RE: Bridal Veil Construction, M-2001-054, adjusted reclamation plan

Revised 7-14-12

Bridal Veil Creek Sediment Basin
Bridal Veil Construction

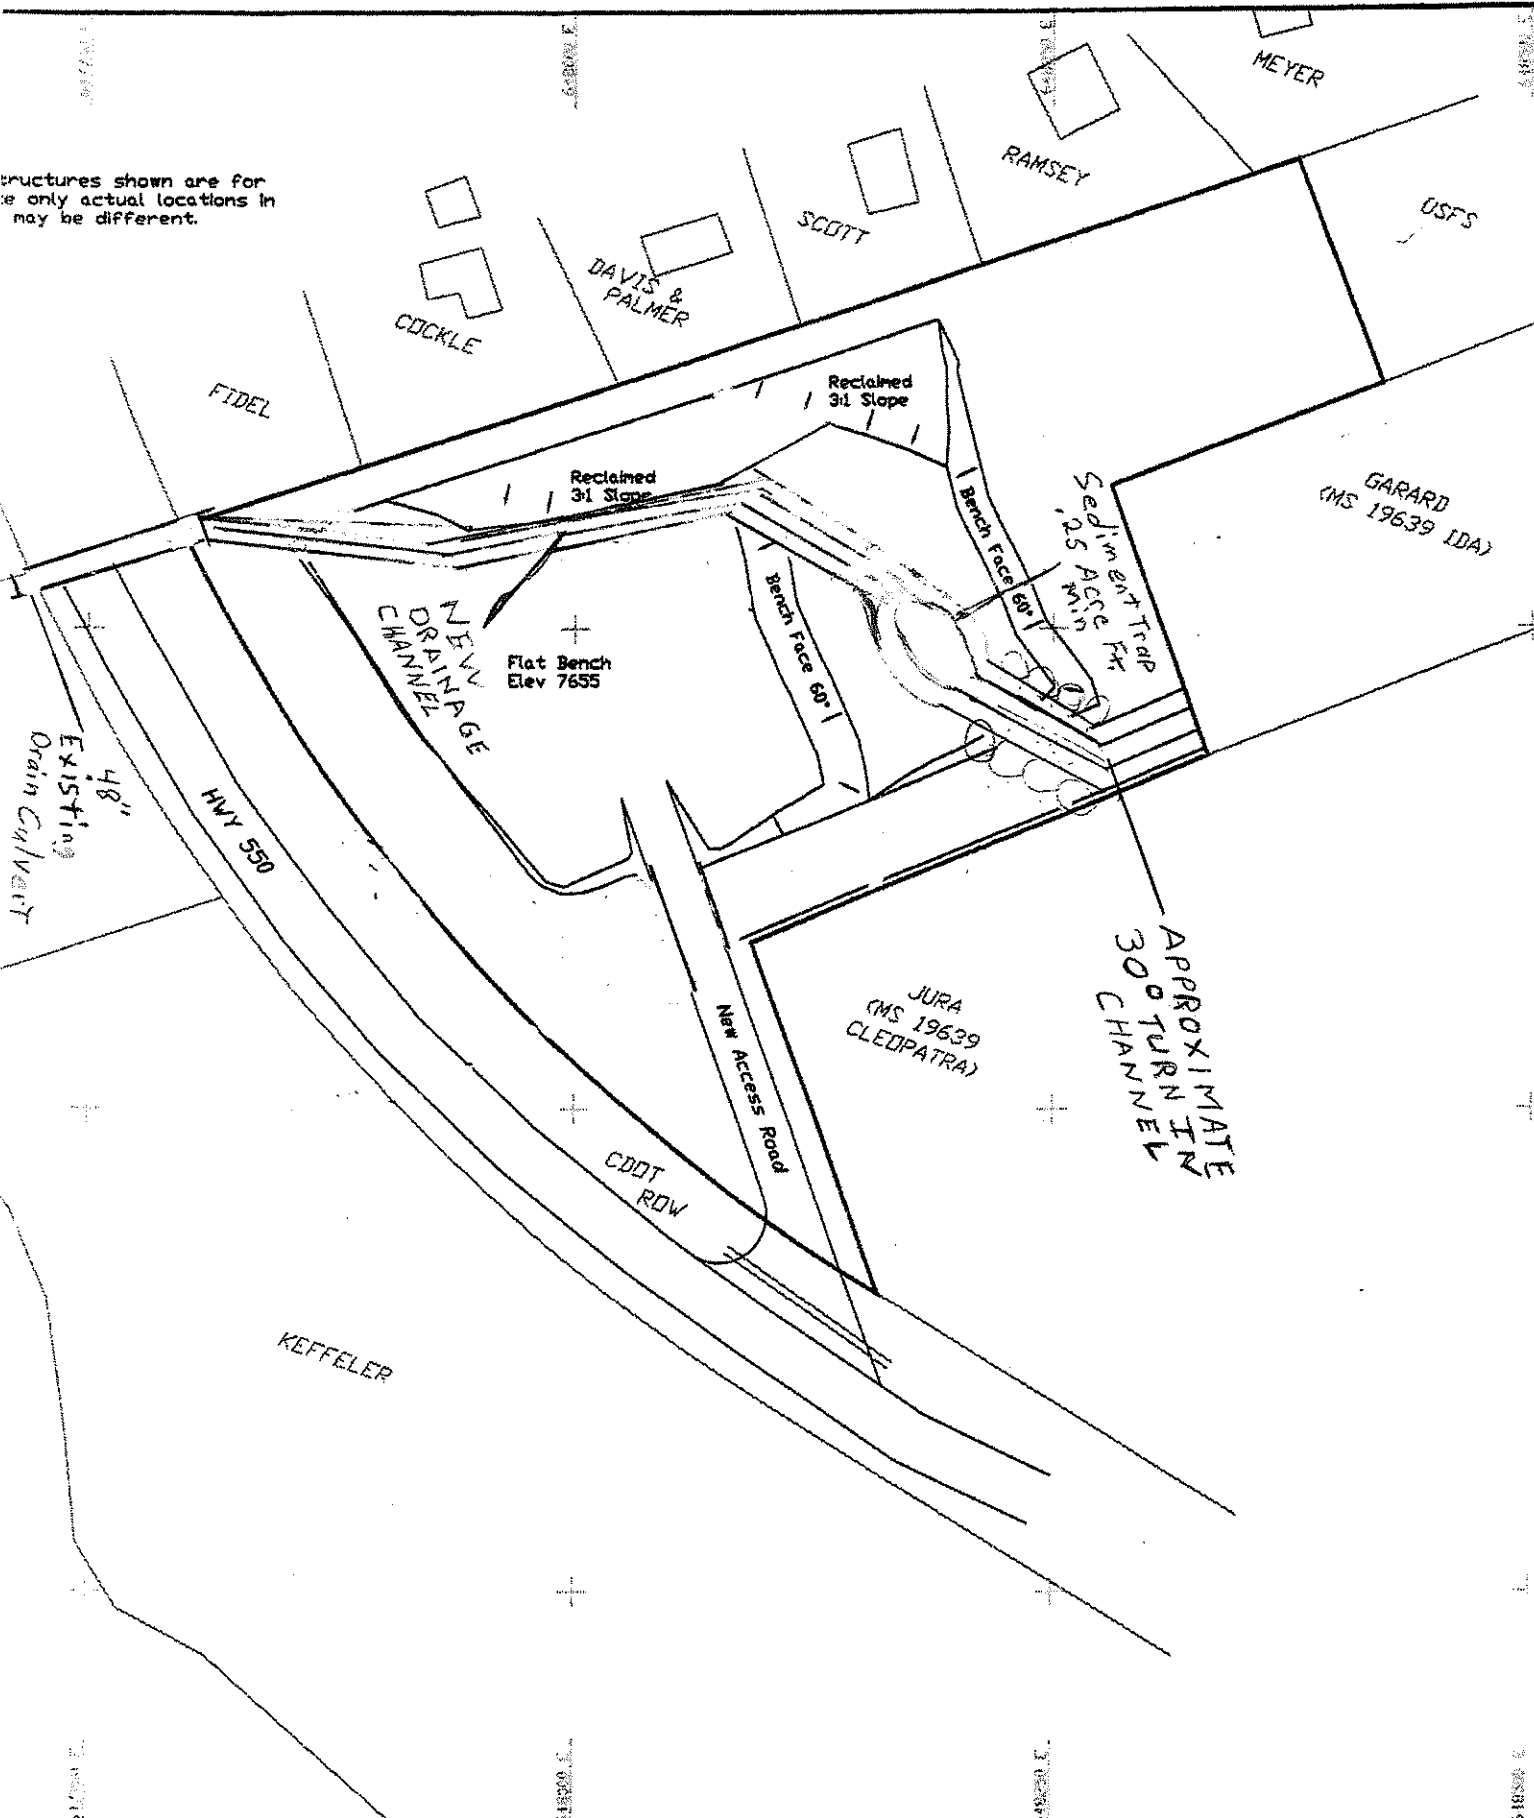
We would like to request an adjustment to our original reclamation plan. I have included a map showing the adjustment that we would like to do, along with the following description and reasoning.

We would like to move the catchment basin east up the channel and to the north of existing channel. We have been saving large boulders for this purpose, and would block the original channel heavily with these. There will be a large, wide bank on the lower (west) side to keep debris contained. The water will exit on the northwest side of the new basin, and run along the original Bridal Veil Creek channel, as shown on older maps. The creek moved before we owned the property. We will use the same engineered spec's on the channel leading to the new catchment basin.

1. When the basin was below the driveway, the debris would block the driveway before it reached the basin. With the basin in the proposed location, the water below the basin would be debris-free, thus less property damage with extreme run-off events.
2. The new natural channel will meet the old original channel, which still exists on the west side of highway 550, thus will not block the highway above the highway culvert which is aligned with the old channel.
3. We will construct water features, which will protect the lower bench and items and belongings which will be there.

Section of 30° Turn In Channel

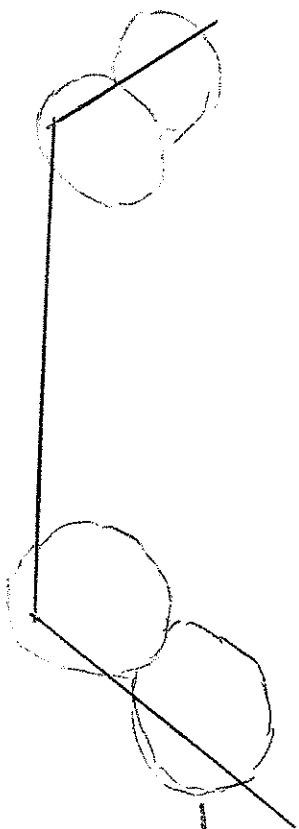
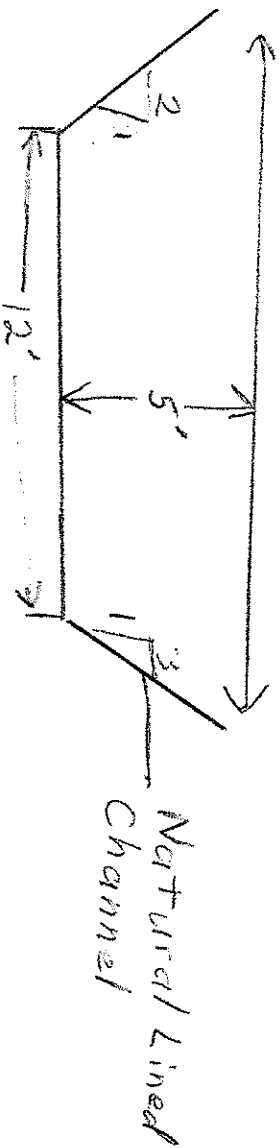
Large Boulders
For Armour on
Banks

New Channel and
Catch Basin
will be designed
such as engineered
Spec's on Detail 3^{II}
Detail 1^{II} and Detail 2^{II}
Except For Rip Rap
on Both Sides of Turn
In Channel going to
Sediment Basin
